Product Change Notice (PCN)

Subject: Package design revision for listed Renesas WFQFN 5x5mm Package

Publication Date: 8/9/2021

Appendix A – Package design revision – mold cap extension

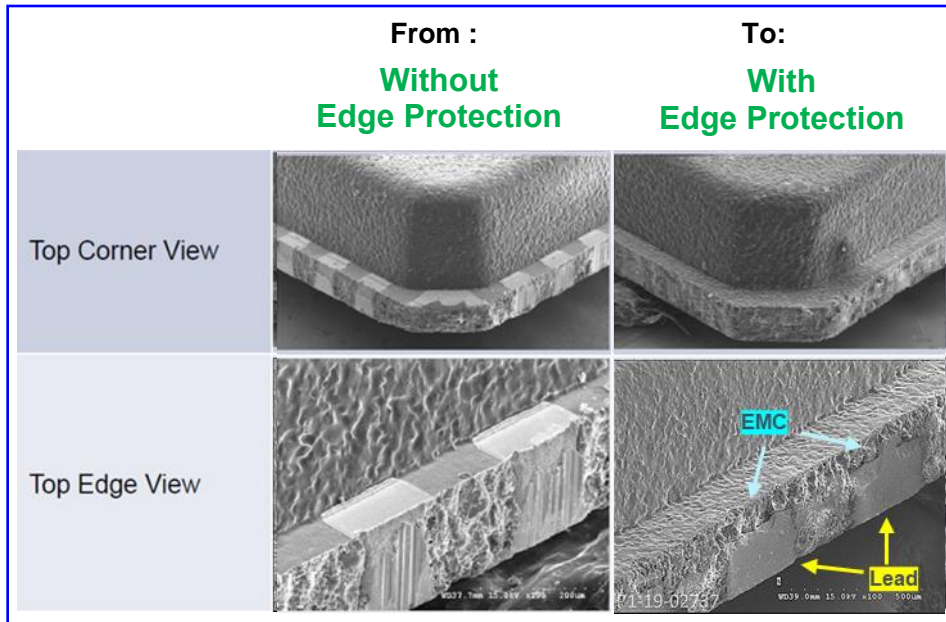
This notice is to advise our customers of a minor design revision for the products listed below. The new design is to extend Mold Cap to cover top exposed lead area which provides more robustness on the Package Flange. Please refer Appendix A for details. This new design will be adopted to all 5x5mm Wettable Flank Quad Flat No Leads (WFQFN) product family.

The change in the product design is being implemented to provide more robustness on the package flange area to strengthens device integrity.
